Rezoning Transportation Analysis

Petition Number: 2020-026

General Location Identifier: Tax ID04940106

Date	Description
03-25-2020	First Review

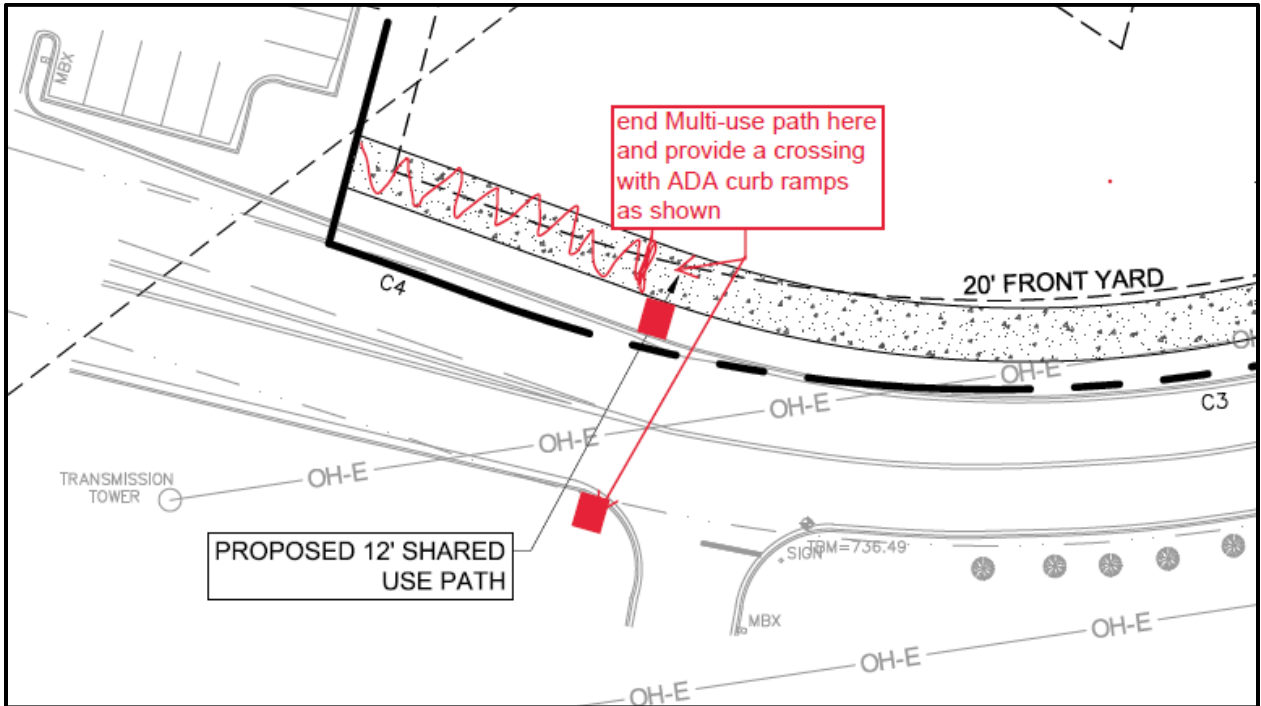
- ~~1. **Curbline** The proposed zoning district has a setback measured from back of the existing or proposed future curbline.
 - ~~a. **Hampton Church Road Name:** The future location of curb and gutter is in its existing location.~~
 - ~~b. **Shopping Center Drive:** The future location of curb and gutter is in its existing location.~~~~

~~The site plan should show the curb and gutter labeled and dimensioned from the centerline for each road.~~

- ~~2. **Traffic Study** A Traffic Impact Study is not necessary for the complete review of this petition. If during the permitting process the site generates more than 2500 daily trips, then a traffic study will be required.~~

- ~~3. The proposed dwelling units per acre exceeds 12. Per Chapter 20 Subdivision ordinance, the petitioner should revise the site plan and conditional note(s) to commit to construct an 8-foot planting strip, and 8-foot sidewalk along Public Street A.~~
- ~~4. The petitioner should revise the site plan and conditional note(s) to commit to providing two ADA curb ramps to provide pedestrian or bike crossing Shopping Center Drive.~~

- ~~5. The petitioner should revise the site plan and conditional note(s) to align the proposed street and driveways across the street to provide a safer access. (Revised on 04-17-220)~~

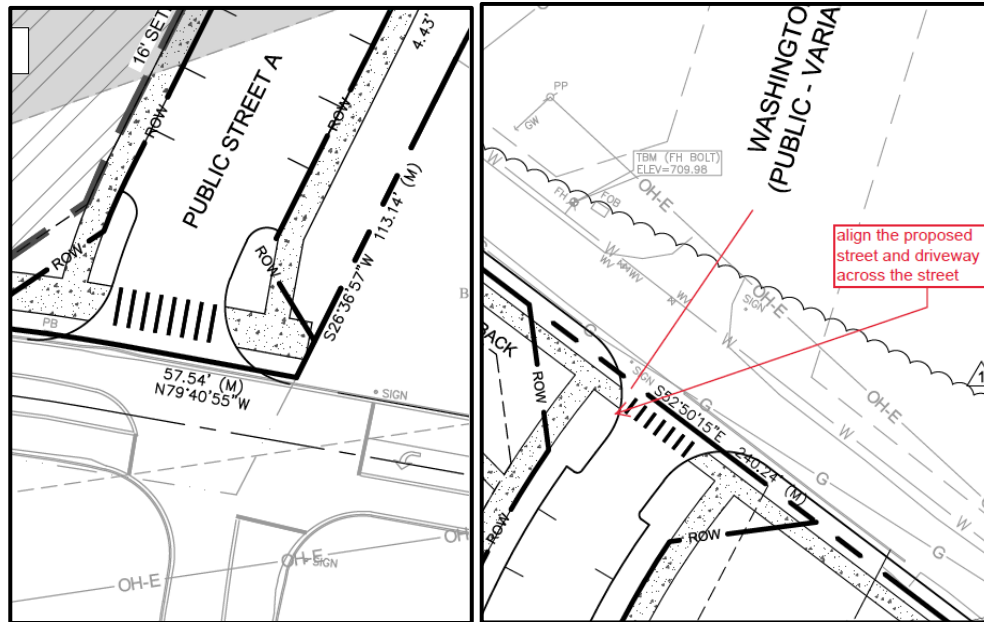
6. The petitioner should revise the site plan to add a note specifying dedication and fee simple conveyance of all rights of way to the City before the site's first building certificate of occupancy is issued. CDOT requests right of way set at 2' behind back of sidewalk where feasible.
7. The petitioner should revise the site plan to add a note specifying all transportation improvements will be approved and constructed before the site's first building certificate of occupancy is issued. The petitioner may phase transportation improvements if said improvements and phasing are explicitly described in site plan notes.
8. **Resolved**-Sample format for comment that is resolved
